INSPECTION REPORT

Inspection Date:	05/25/2021	
Time:	Entry: 1:00 p.m.	Exit: 3:06 p.m.
Weather:	Periodic overcast with evidence of recent precipitation	
Media:	Clean Water Act (CWA)	
Regulatory Program:	CWA NPDES/Industrial Stormwater	
Permittee Name(s):	Clyde Companies (Sunroc Corporation)	
Permittee Addresses:	501 E. 41st St. (Sunroc Corporation)	
Permittee City, State, Zip Code:	Garden City, ID 83714	
Facility Name:	Maddens Facility	
Facility Physical Location:	10340 US-20/26	
	Latitude/Longitude	43.6666°, -116.6018°
City, State, Zip Code:	Caldwell, ID 83605	
Facility Contact(s):	Tim Henderson, Crew Lead Phone: (208) 343-6965 Email: Not provided	
County:	Canyon County, Idaho	
NPDES Permit:	2015 EPA Multi-Sector General Permit (MSGP)	
EPA Facility Identifier:	IDR053240	
Industrial Sector:	Sector E: Glass, Clay, Cement, Concrete, and Gypsum Product Manufacturing Facilities	
Subsector:	E1, Concrete Product Manufacturers	
Primary SIC Code(s):	3271 – 3273, Concrete Block to Ready-Mixed Concrete

Maddens Facility
Industrial Stormwater Inspection Report

Exhibit 3. SWPPP Site Map (map dated November 2018). The SWPPP Site Map was missing several elements required by the Permit (see Section III – Areas of Concern).

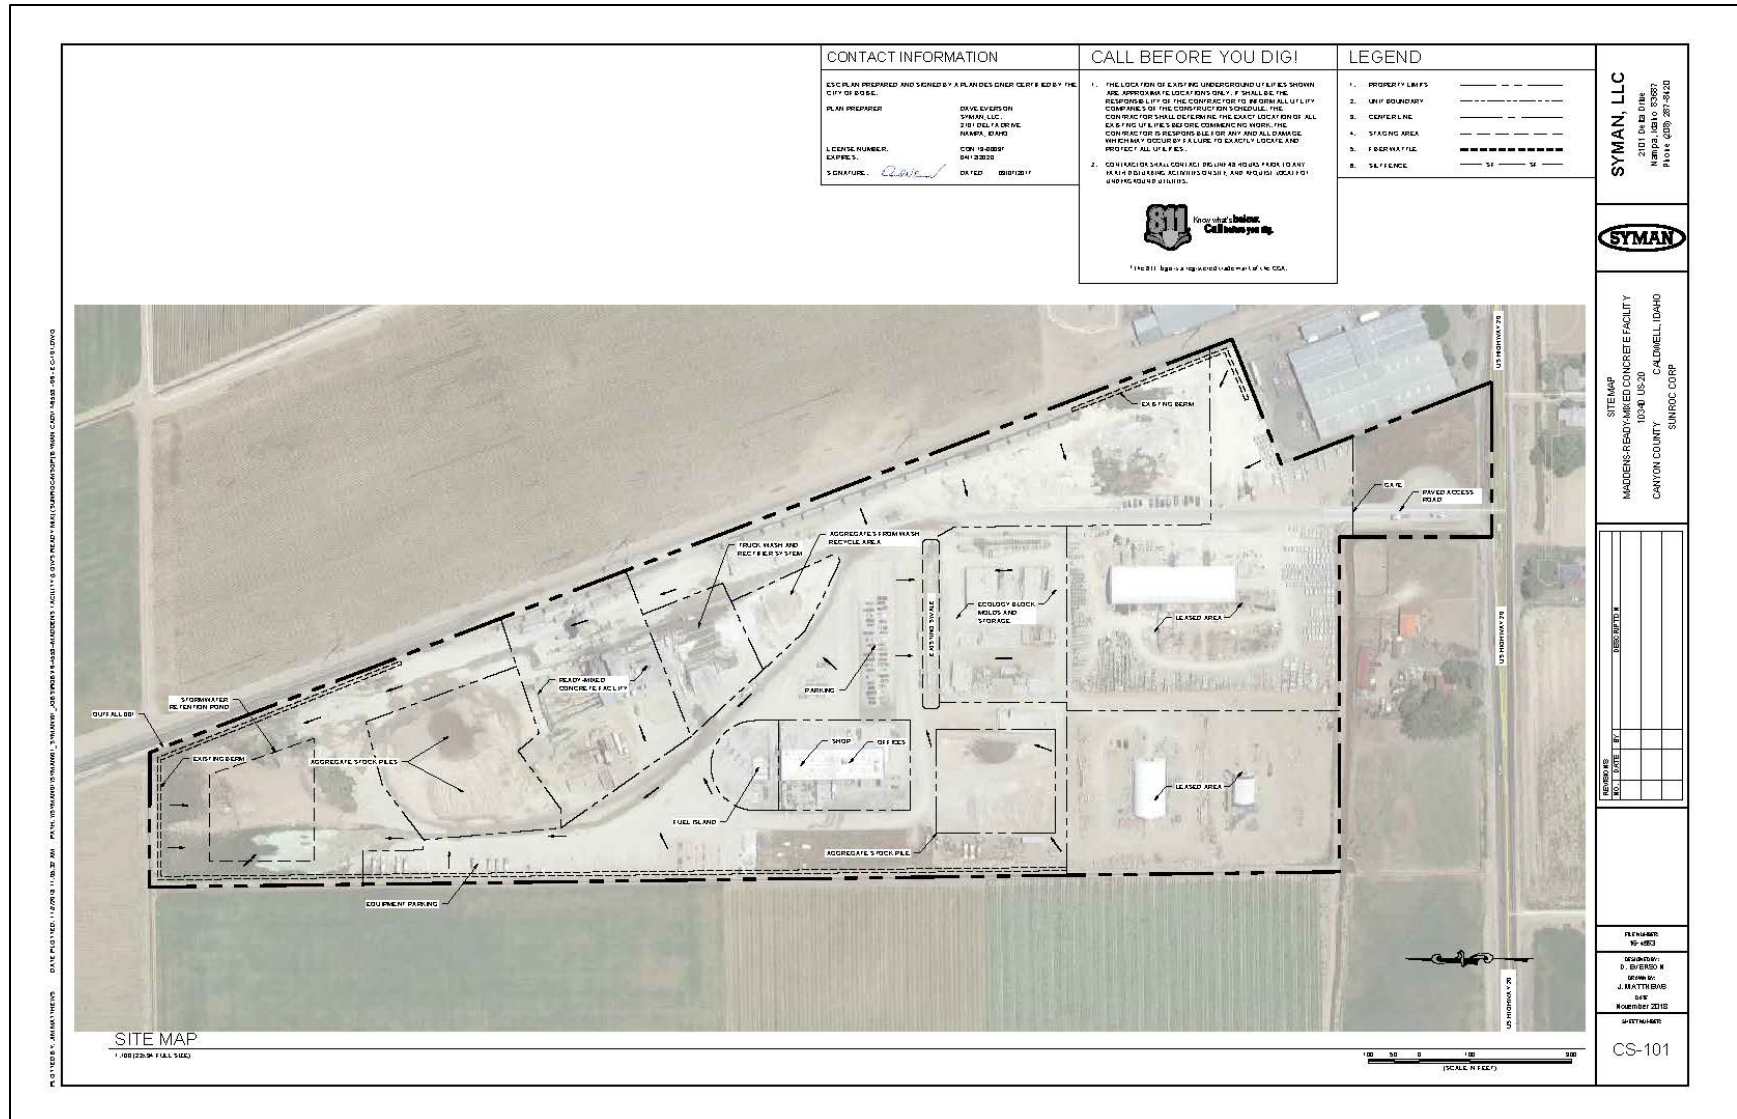
Area of Concern 4

The SWPPP site map was not reflective of Facility conditions at the time of the inspection. During the inspection, I observed the following areas and features at the Facility that were not identified on the SWPPP site map:

- Storm drain inlet and associated onsite subsurface infiltration structure described by Mr. Henderson (refer to Photographs 10 and 11).
- Impervious valley gutters that run north on both the east and west sides of the batch plant and aggregate stockpile that flow into the stormwater retention basin in the northern corner of the Facility (refer to Photographs 12, 13, and 15).

- Hardened and excavated concrete waste piles located on the southern edge of the stormwater retention basin (refer to Photograph 5).
- Outdoor washing area on the north side of the maintenance building (refer to Photograph 9).

- Uncovered truck wash rack and associated concrete stripper storage area on the northeast side of the Facility (refer to Photographs 15 and 16).
- Bulk chemical storage tanks of calcium chloride, phosphoric acid, and concrete additives at the batch plant (refer to Photograph 17).

- Rail line along the Facility's eastern perimeter that brings raw materials to the Facility (refer to Photographs 6, 7, and 14).
